## **WEST POINT PLAZA SUBDIVISION**

***Revised for the August 21<sup>st</sup> meeting:***

APPLICATION NUMBER 3 DATE August 21, 2014

# DETAIL SITE PLAN

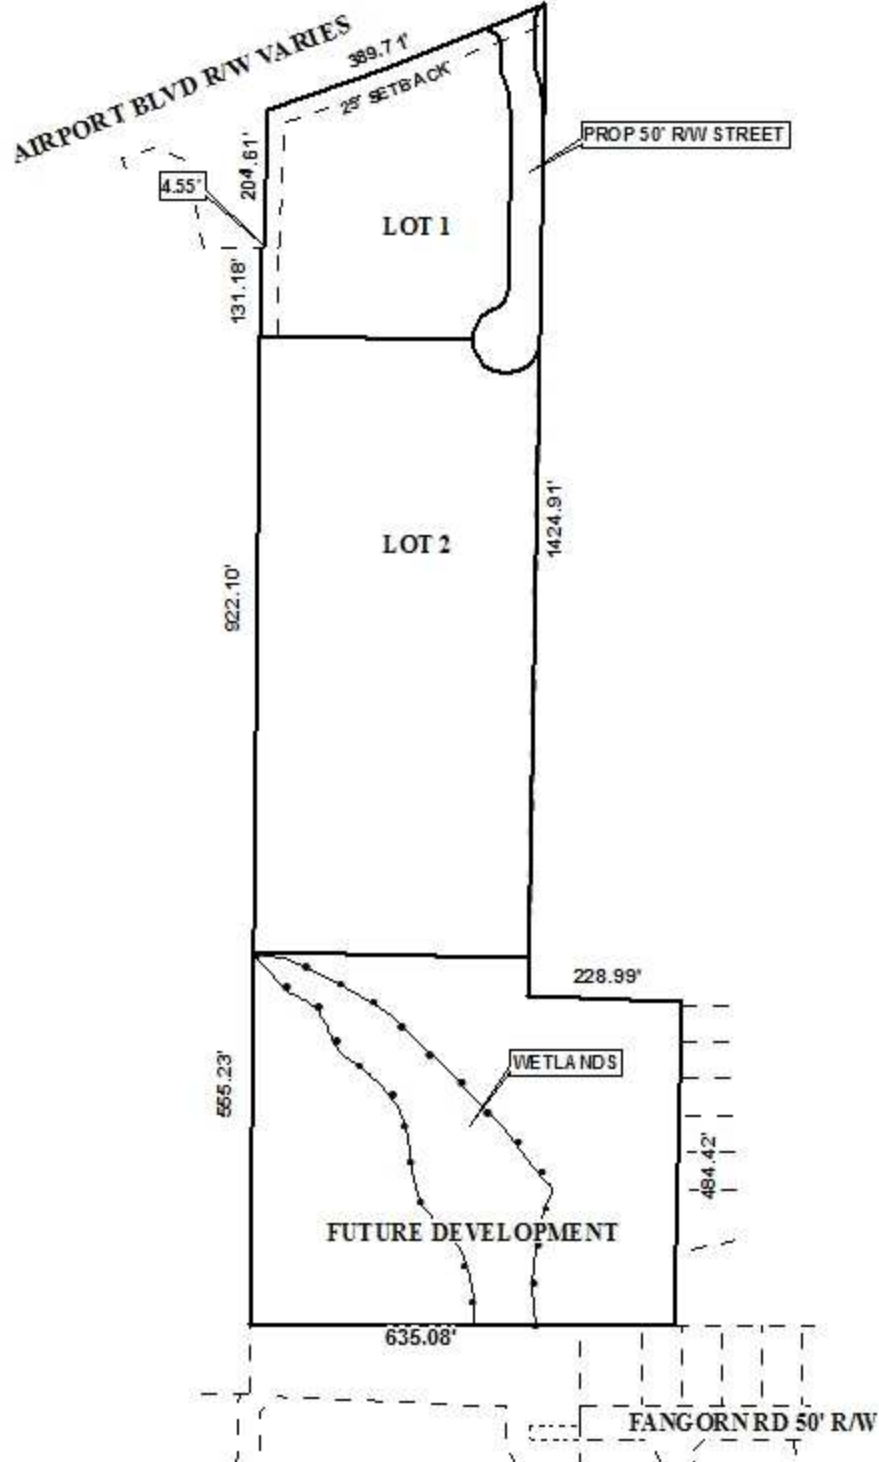
*The preliminary plat depicts West Point Plaza Drive, a newly proposed public minor road, with a compliant 50' right-of-way as required by Section V.B.14. The plat also depicts a turnaround right-of-way diameter of 100' providing a 50' radius; however a turnaround right-of-way diameter of 120' to provide a 60' radius is required. The plat should be revised to reflect Sections V.B.14 and V.B.15 of the Subdivision Regulations.*

*The 25' minimum building setback line is depicted along Airport Boulevard. However, the minimum setback line is not depicted where the lots abut West Point Plaza Drive. If approved, the 25' minimum building setback should be illustrated along Airport Boulevard and West Point Plaza Drive on the Final Plat.*

*The lots are labeled in acres but not in square feet. If approved, revisions should be made to depict the lot sizes in square feet and acres, or a table should be furnished on the Final Plat providing the same information.*

*The plat indicates a small portion of the site along West Point Plaza Drive as "Common Area". A note should be placed on the Final Plat stating maintenance of this area will be the responsibility of the property owners.*

*The plat illustrates wetlands on a portion of the site labeled "Future Development". The presence of wetlands indicate that the area may be environmentally sensitive; therefore, the approval of all applicable federal, state and local agencies would be required prior to issuance of permits or LD activities.*

- 1. revision of the plat to depict the lot sizes in square feet and acres, or the furnishing of a table on the Final Plat providing the same information;*
- 2. labeling of the right-of-way width of Airport Boulevard;*
- 3. dedication to provide 50' from the centerline of Airport Boulevard if the right-of-way is less than 50' in width;*

4. *revise the plat to depict a turnaround right-of-way diameter of 120' to provide a 60' radius for West Point Plaza Drive;*
5. *revision of the plat to depict the 25' minimum building setback line along Airport Boulevard and West Point Plaza Drive;*

6. *placement of a note on the Final Plat stating lots 1 and 2 are limited to one curb-cut to West Point Plaza Drive, with the size, location and design of all curb-cuts to be approved by Mobile County Engineering and conform to AASHTO standards;*
